TECHNICAL EVALUATION OF THE RESPONSE TO  
ATTACHMENT 1 OF ITEM 11.F.1 OF NUREG-0737  
"ADDITIONAL ACCIDENT MONITORING INSTRUMENTATION"  
FOR THE  
H. B. ROBINSON STEAM ELECTRIC PLANT, UNIT 2  
(DOCKET NO. 50-261)

SAFETY CONCERN ASSOCIATED WITH REACTOR VESSEL LEVEL  
INSTRUMENTATION IN BOILING WATER REACTORS

by the  
OFFICE FOR ANALYSIS AND EVALUATION  
OF OPERATIONAL DATA

FIGURE 1 - Reactor Vessel Level Instrumentation

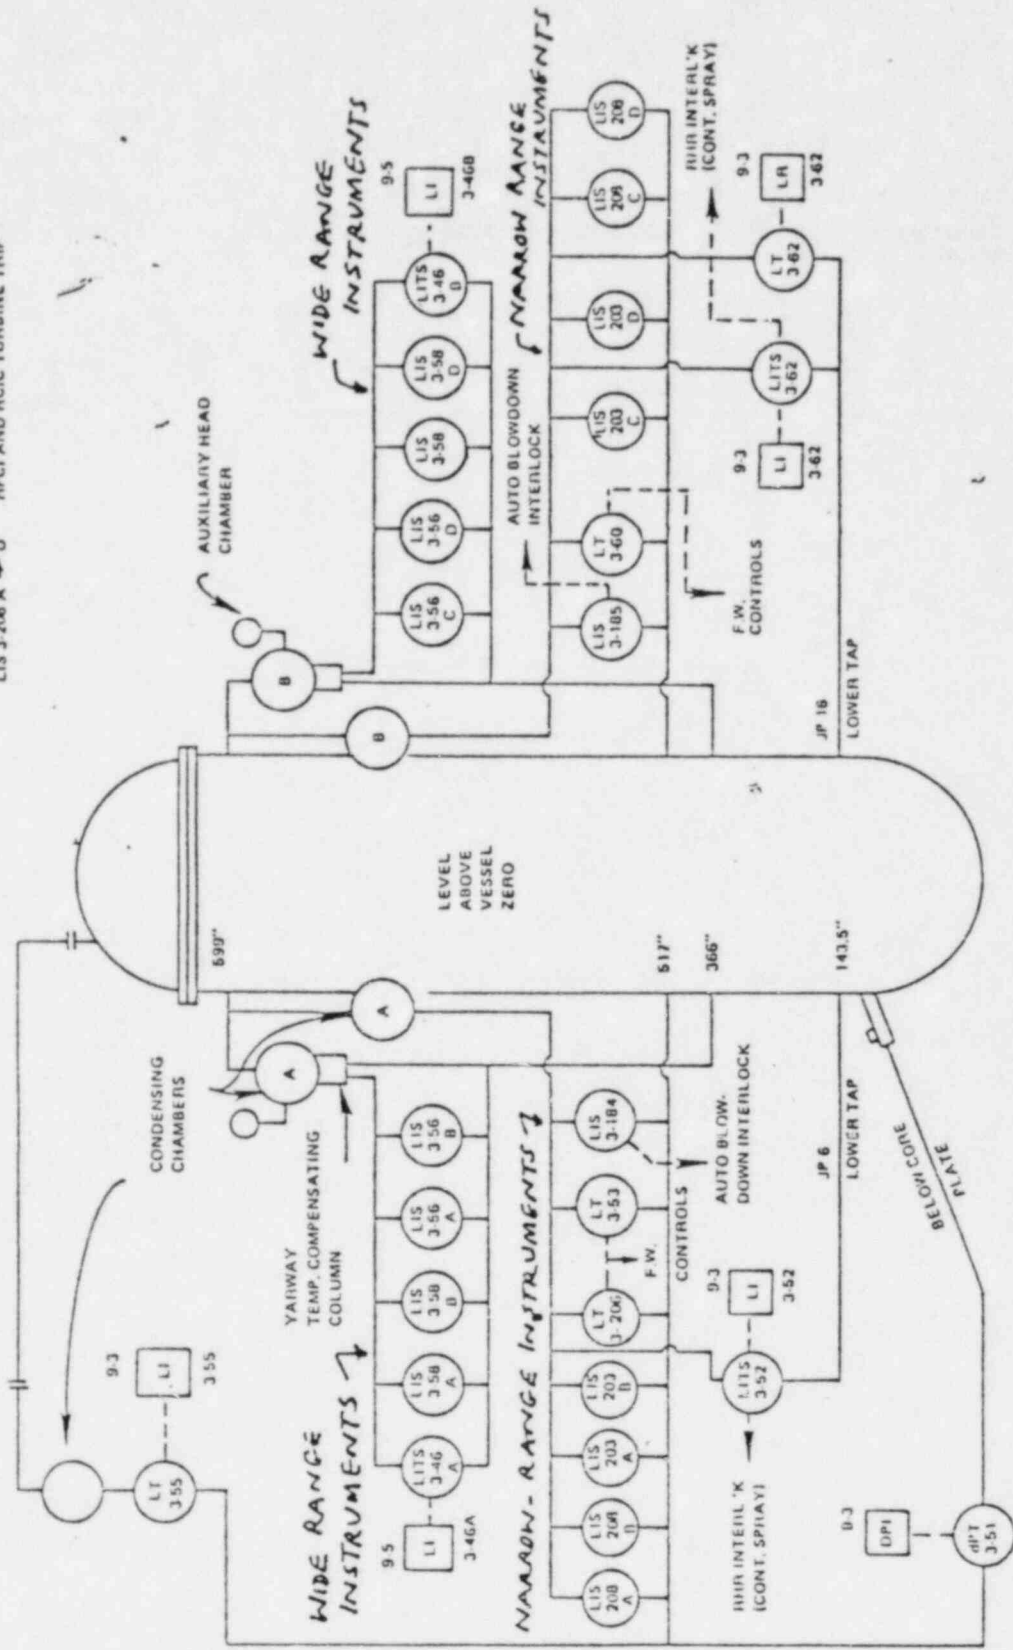
Referring to Figure 1, if such a failure was to occur in the reference leg of the normal range level sensors A and B, then LIS 3-208A&B, LIS 3-203 A&B, LIS 3-184, LT 3-53 and LT 3-206 would all sense an increasing level. If LT 3-53 was selected by the control room operator for the level input to the feedwater control system (with the feedwater control mode switch in either the one or three element control), then the feedwater system would reduce feedwater flow into the reactor vessel. This would tend to decrease the actual reactor vessel water level. If prompt operator action is not taken to manually control the feedwater system, then eventually the vessel level would reach the low level scram setpoint. However, scram level sensors LIS 3-203A&B would sense a high level and would not actuate. Therefore, LIS 3-203C&D on the redundant instrument lines would be required to provide the necessary protective action.

In such an event the control room level indicators, recorders and alarms would be providing ambiguous level information to the operator. The two accident range indicators (LI 3-46 A&B) would still show true level, but only one of the normal range level indicators (in this instance LI 3-60) would indicate true level. The other two normal range level indicators (LI 3-53 and LI 3-206), as well as the level recorder pen, would show an erroneous high level. If, on the other hand, the failure was to occur in the reference leg associated with normal level sensors C and D (i.e.,

LIS 3-203 C&D, LIS 3-208 C&D, LIS 3-185 and LT 3-60) and if LT 3-60 was selected for level input to the feedwater control system, the effects would be similar, with the following exceptions: (1) only one normal range level indicator (LI 3-60) and the level recorder would show the erroneous increasing level; and (2) the high level turbine/reactor trip would not occur, since only one of the three level transmitters associated with the feedwater control system would be affected.

This interaction between the feedwater control system and the reactor protection system is the safety concern in that the initiating instrument line failure could cause adverse feedwater control system action requiring low vessel level protective actions and, at the same time, would also prevent proper action of certain low level protection system channels.

- (1) Action should be implemented to assure that automatic and manual safety-related low-low level start and high pressure injection functions of HPCI and RCIC turbines are not prevented or delayed by the non-safety-related high level trip. For example, the control system of HPCI and

RCIC turbines could be modified to provide a low-low level start signal which overrides the high level trip signal.

- (2) Action should be implemented to assure that protective functions are provided in spite of any adverse control system-protection system interaction in the narrow range level instrumentation. For example, the protective functions provided by the narrow range level sensors could also be provided by the wide range level sensors (In employing the wide-range level instrumentation, the desired output signal quality in terms of sensitivity, resolution, accuracy and repeatability must be considered to assure that the initiating signals achieve the required protective function.). This approach would be consistent with the concept of "alternate channels" as defined in paragraph 4.7.4.1 of IEEE Standard 279-1971.
